UNITED STATES OF AMERICA  
NUCLEAR REGULATORY COMMISSION

CONSOLIDATED EDISON COMPANY OF )  
NEW YORK, INC. (Indian Point )  
Unit No. 2) )

Docket No. 50-247

CONSOLIDATED EDISON'S  
ANSWER TO NOTICE OF PROPOSED  
IMPOSITION OF CIVIL PENALTY

PLOT OF BEST ESTIMATE OF WATER LEVEL IN REACTOR VESSEL PIT VERSUS TIME  
BASED ON ACTUAL WATER LEVEL OBSERVATIONS

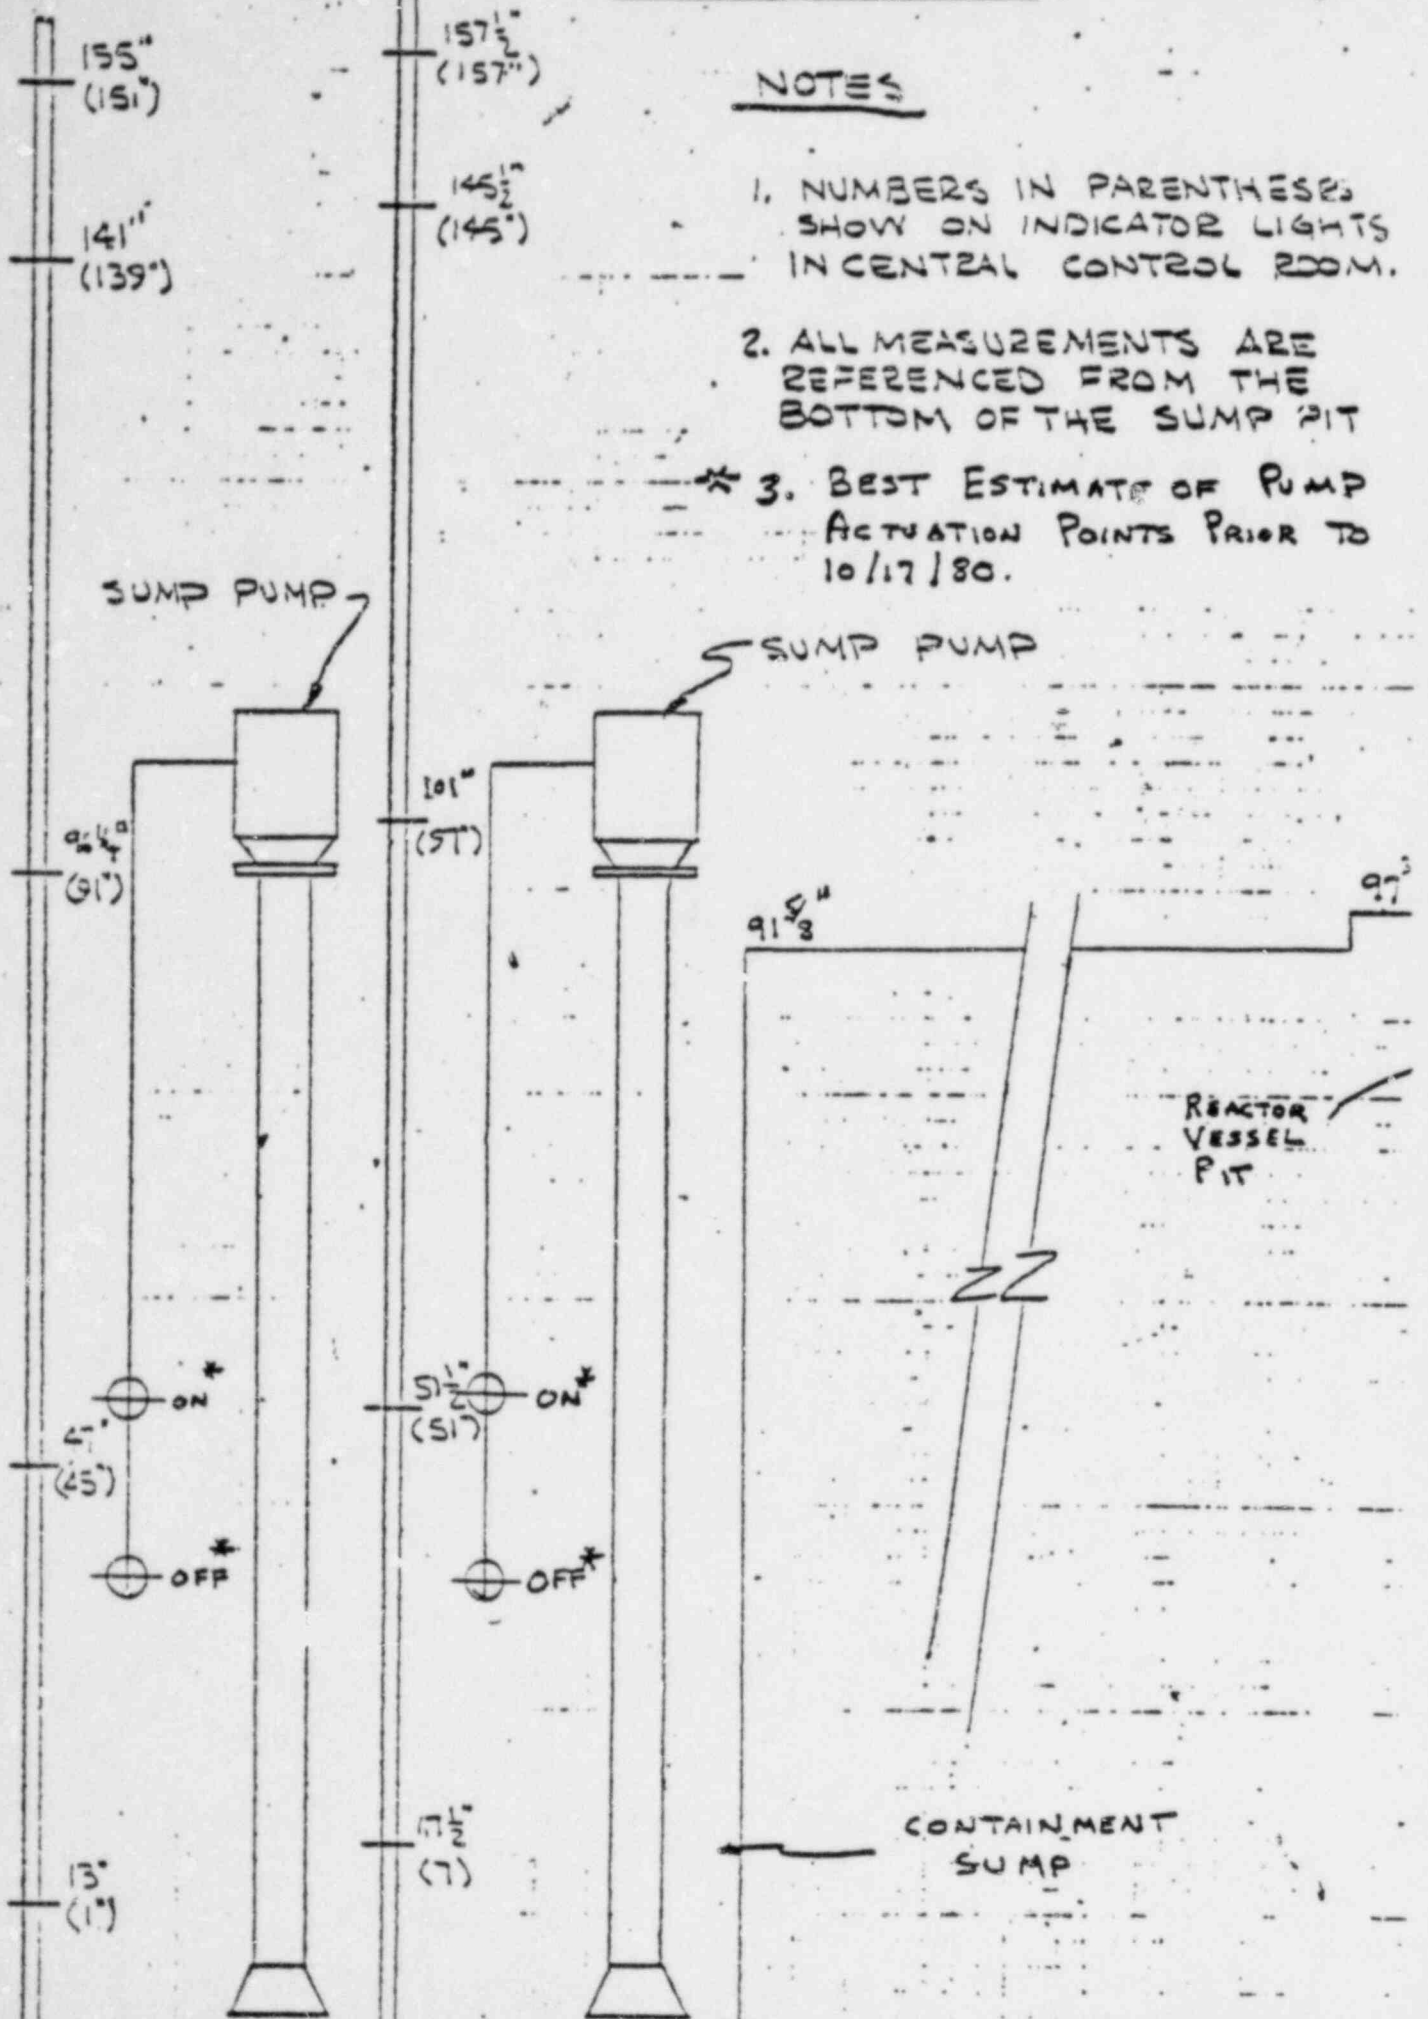
An NRC Reactor Vessel Pit Water Level observation curve (Figure 1) was developed by reviewing and evaluating various logs and testimony of individuals with first hand knowledge of the Reactor Vessel Pit water level, observed on their various entries into the Vapor Containment. The best estimate water levels were then plotted against times gleaned from Vapor Containment entry logs, operator logs and eye-witness accounts of the activities of the water level observing individuals. The resulting plot supports the licensee's estimate of maximum potential Reactor Vessel submergence and shows only one peak without level cycling.

NRC SUMMARY  
TOTAL NUMBER OF MWR'S ISSUED  
FOR FAN COOLER UNIT AND RELATED  
SERVICE WATER PIPING LEAK  
REPAIRS BY YEARLY QUARTERS

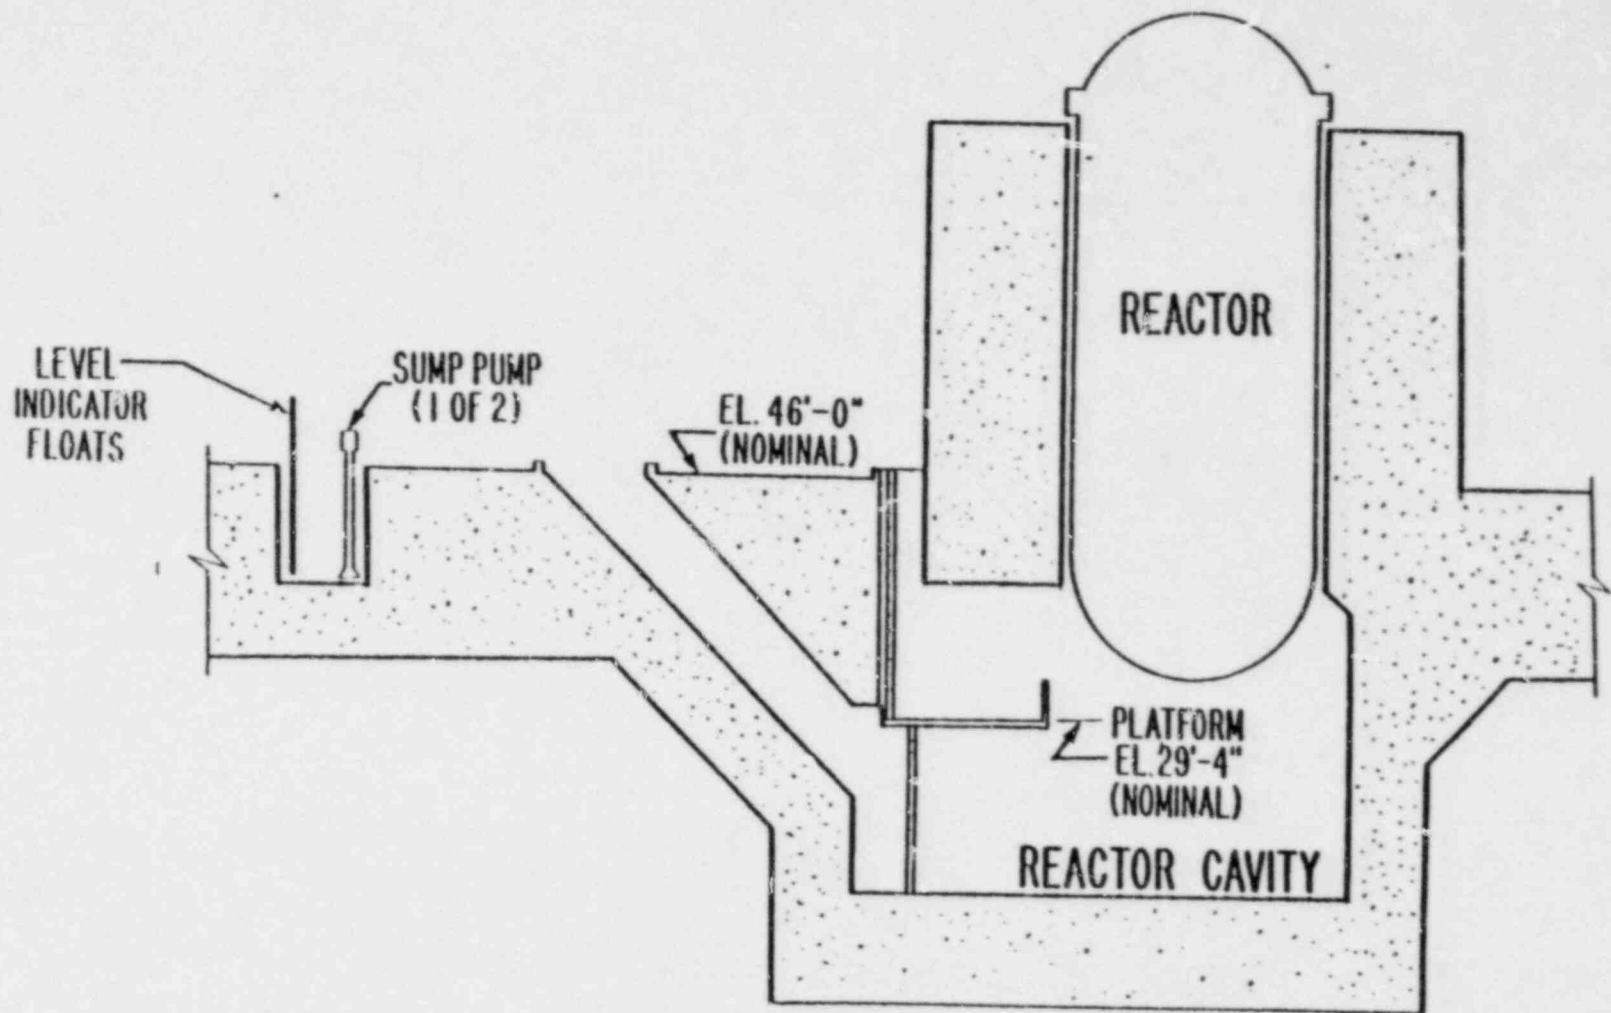
The licensee provided to the NRC investigation team summaries of seven additional M.W.R.s., related to repairs of Fan Cooler Unit (F.C.U.) Service Water leaks not previously included on their Fan Cooler Unit maintenance summary. The team reviewed the information and revised NRC Investigation Report 50-247/80-19, figures 4 and 6, to reflect the additional information.

The NRC investigation team acknowledged the failures shown in figure 6 of NRC Investigation Report 50-247/80-19 represent a small percentage of components available for failure, but maintains the increasing frequency of leaks, as indicated in figure 4 of the same report, should have been given over-riding consideration.
